# Manitoba Public Utilities Board

## Manitoba Hydro NFAT IEC Transmission Line Construction and Management Report – Confidential Version

**PREPARED FOR: MANITOBA PUBLIC UTILITIES BOARD**  
**PREPARED BY: POWER ENGINEERS, INC.**

1  
2 **Figure 1: Keyask Transmission Project**

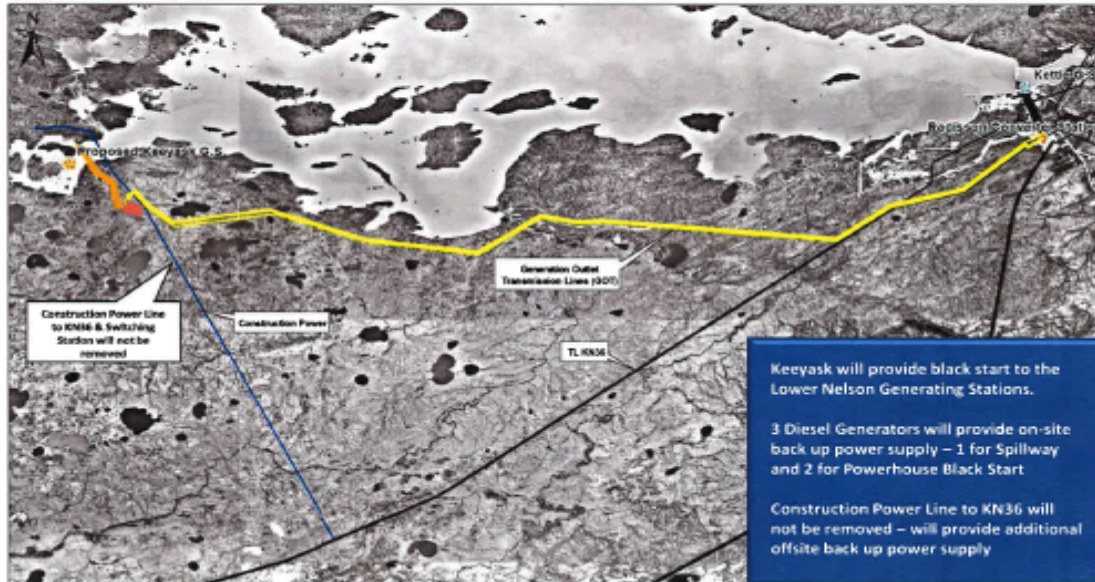
26 In 2012 Dollars, the estimate for the Generator outlet lines and Unit lines (KR1, KR2, & KR3)  
 27 totaling 110 km in length amounts to \$727,272/km. We questioned this amount as being excessively  
 28 high, even taking into account winter construction. A telephone conversation [C, pg 58] on  
 29 December 11, 2013 with Joel Wortley provided answers that we can accept.

- 30 a. The project is very short and efficiencies of longer lines cannot be obtained.
- 31 b. The project requires 2 mobilizations because it is constructed in two different years.
- 32 c. The river crossing is difficult and expensive.

34 These are valid reasons for increasing estimated costs. Without these mitigating factors POWER  
 35 would estimate the cost of a similar 138 kV line at about \$639,000/km [E, pg 66]. The area,  
 36 climatologic conditions and the multiple mobilizations all contribute to costs that can be much higher  
 37 than a line without these constraints. Allowing a 15% added cost for short projects, an extra  
 38 \$250,000 for the second mobilization in 2019, and a river crossing cost adder of \$100,000 per line,  
 39 produces an estimate of about \$97,018,000 for the project in 2012 Dollars, (738,000/km). Our  
 40 estimate and MH's estimate fall within 5%, which we consider to be an acceptable range.

1  
2 **Figure 2: Conawapa Transmission Project**  
3

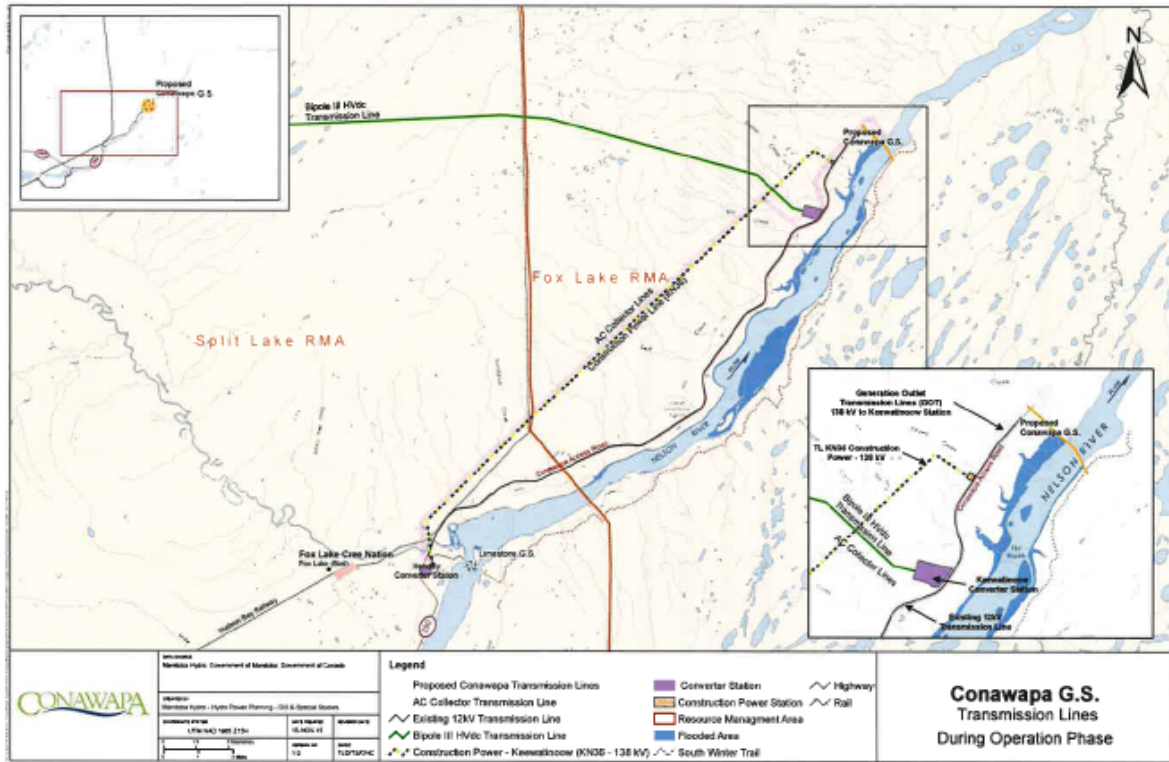
8  
9 The MH per-km cost estimate for the 230 kV lines in 2012 Dollars is \$286,000/km. (\$10 million/35  
10 km)

14  
15 POWER Engineers prepared an estimate for a similar 230 kV line in similar ground conditions and  
16 made adjustments for winter construction [E, pg 70]. We included the structure information  
17 provided by MH, and made adjustments based on the ground conditions. Our estimate in 2013  
18 Dollars is \$344,000/km with an expected accuracy of ±20%). The estimates provided in the NFAT  
19 filing fall at the very low range of our expected cost for 230 kV line construction in similar terrain.
